Access Compliance Report

Public Rights-of-Way

Intersection ID: 52440	Main Street: WOODWARD_AV	Cross Street: DOUBLE_OAKS_RD	Location: E
ADA ID: B10FE1A40D26	Ramp Type: PerpDiag	Initial Pass/Fail: Fail	Overall Compliance: No
Severity Score: 12.5			
Codes/Mitigation Info/Possible Solution		Field Measurements/Component Compliance

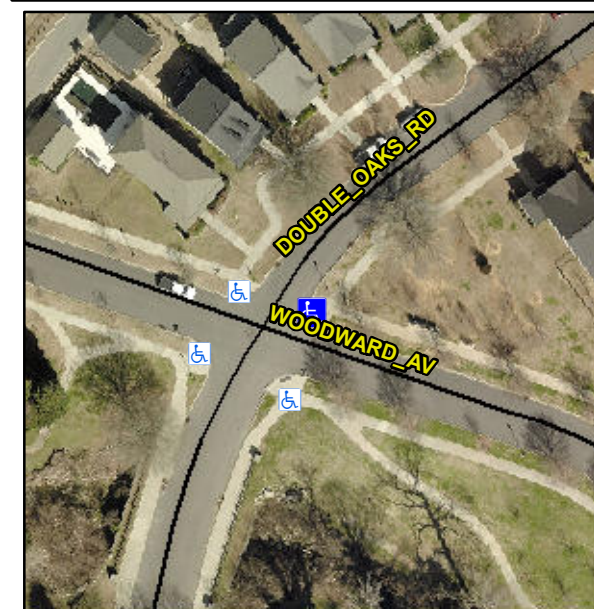
R304.2.2

Compliance	Description	Data	Compliance	Description	Data
N/A	Ramp Length (in)	27.0	No	Ramp Slope (%)	10.0
Yes	Ramp Width (in)	68.5	Yes	Ramp XSlope (%)	1.1
N/A	Flare Type LT	N/A	N/A	Flare Type RT	N/A
N/A	Flare Slope LT (%)	N/A	N/A	Flare Slope RT (%)	N/A
N/A	Flare Traversable LT?	N/A	N/A	Flare Traversable RT?	N/A
N/A	Landing Length (in)	N/A	N/A	DWS Provided?	N/A
N/A	Landing Width (in)	N/A	N/A	DWS Contrast?	N/A
N/A	Landing Slope (%)	N/A	N/A	DWS Length (in)	N/A
N/A	Landing X Slope (%)	N/A	N/A	DWS Full Width?	N/A
N/A	Landing Curb? (Y/N)	N/A	N/A	DWS Offset (in)	N/A
N/A	Shared Landing?	N/A			
N/A	Gutter Ponding?	N/A	N/A	Gutter Slope (%)	N/A
N/A	Gutter Lip Ht (in)	N/A	N/A	Gutter X Slope (%)	N/A
N/A	Painted X Walk1?	No	N/A	Painted X Walk2?	No
	X Walk 1 Direction	To NW		X Walk 2 Direction	To SW
N/A	X Walk 1 Width (in)	N/A	N/A	X Walk 2 Width (in)	N/A
	X Walk 1 Slope (%)	6.5		X Walk 2 Slope (%)	4.9
	X Walk 1 X Slope (%)	4.5		X Walk 2 X Slope (%)	8.7

Remove & Replace Curb Ramp With Two New Directional Ramps or Equivalent.
